SUBJECT: REQUEST FOR ADDITIONAL INFORMATION PERTAINING TO INDIVIDUAL
PLANT EXAMINATION OF EXTERNAL EVENTS (IPEEE) FOR ARKANSAS
NUCLEAR ONE, UNITS 1 AND 2 (TAC NOS. M83588 AND M83589)

ARKANSAS NUCLEAR ONE

Request For Additional Information on IPEEE Submittal

Figure A.1 Sensitivity of the hot gas layer temperature predictions to the assumed heat loss factor.

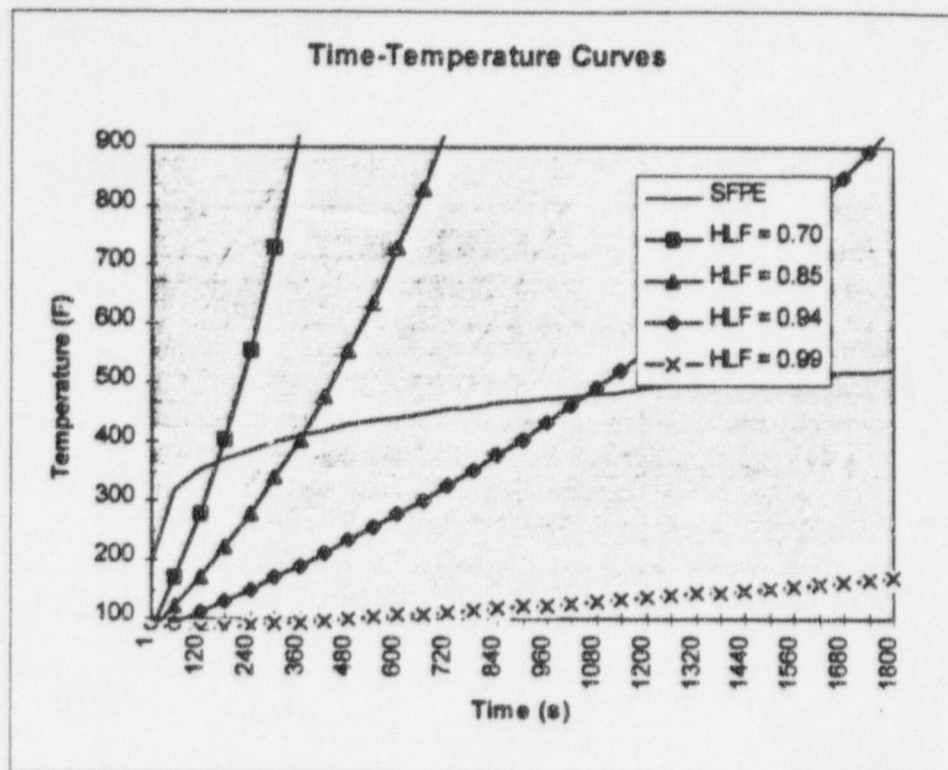
- 4. The heat loss factor is defined as the fraction of energy released by a fire that is transferred to the enclosure boundaries. This is a key parameter in the prediction of component damage, as it determines the amount of heat available to the hot gas layer. In Fire-Induced Vulnerability Evaluation (FIVE), the heat loss factor is modeled as inversely related to the amount of heat required to cause a given temperature rise. Thus, for example, a larger heat loss factor means that a larger amount of heat (due to

a more severe fire, a longer burning time, or both) is needed to cause a given temperature rise. It can be seen that if the value assumed for the heat loss factor is unrealistically high, fire scenarios can be improperly screened out. Figure A.1 provides a representative example of how hot gas layer temperature predictions can change assuming different heat loss factors. Note that: 1) the curves are computed for a 1000 kW fire in a 10m x 5m x 4m compartment with a forced ventilation rate of 1130 cfm; 2) the FIVE-recommended damage temperature for qualified cable is 700°F for qualified cable and 450°F for unqualified cable; and, 3) the SFPE curve in the figure is generated from a correlation provided in the Society for Fire Protection Engineers Handbook [A.1].

Based on evidence provided by a 1982 paper by Cooper et al. [A.2], the EPRI Fire PRA Implementation Guide recommends a heat loss factor of 0.94 for fires with durations greater than five minutes and 0.85 for "exposure fires away from a wall and quickly developing hot gas layers." However, as a general statement, this appears to be a misinterpretation of the results. Reference [A.2], which documents the results of multi-compartment fire experiments, states that the higher heat loss factors are associated with the movement of the hot gas layer from the burning compartment to adjacent, cooler compartments. Earlier in the experiments, where the hot gas layer is limited to the burning compartment, Reference [A.2] reports much lower heat loss factors (on the order of 0.51 to 0.74). These lower heat loss factors are more appropriate when analyzing a single compartment fire. In summary, (a) hot gas layer predictions are very sensitive to the assumed value of the heat loss factor; and (b) large heat loss factors cannot be justified for single-room scenarios based on the information referenced in the EPRI Fire PRA Implementation Guide.

For each scenario where the hot gas layer temperature was calculated, please specify the heat loss factor used in the analysis. The EPRI FIVE methodology, which was accepted by the USNRC for use in the IPEEE assessments, recommended the use of 0.7 for the heat loss factor (see FIVE Section 10.4, page 10.4-21). For any fire scenario frequency estimates if the analysis is performed consistent with the FIVE methodology that used a heat loss factor larger than 0.7, please assess the impact on core damage frequency.
